**HAYES HIGGINS PARTNERSHIP  
CHARTERED ENGINEERS • PROJECT MANAGERS**

**Our Ref:** 17D070/01  
**Project Ref:** 10 Units at Old Nangor Road (Simon)  
**Re:** Planning Application Drainage Submission – response to queries raised additional information report of the Planning Authority dated 20/12/2022  
South Dublin County Council Preplanning Ref: SD22A/041  
**Date:** September 23

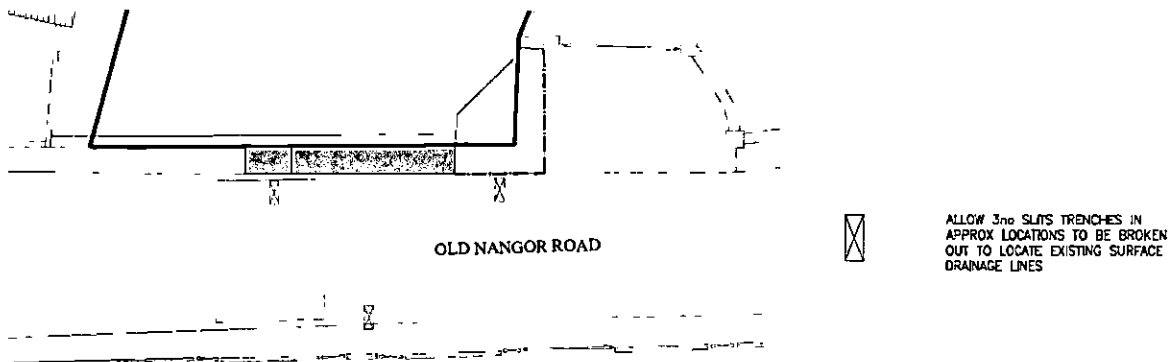
***4.Clarification and provide details of the existence of a public surface water sewer northeast of site. The applicant is advised to consult with the Water Services Section prior to responding***

Opening up works of the road to the front of the site are to be completed in order to confirm the details of the existence of a public surface water sewer. Refer to the below image to show the location of opening up works to be completed.
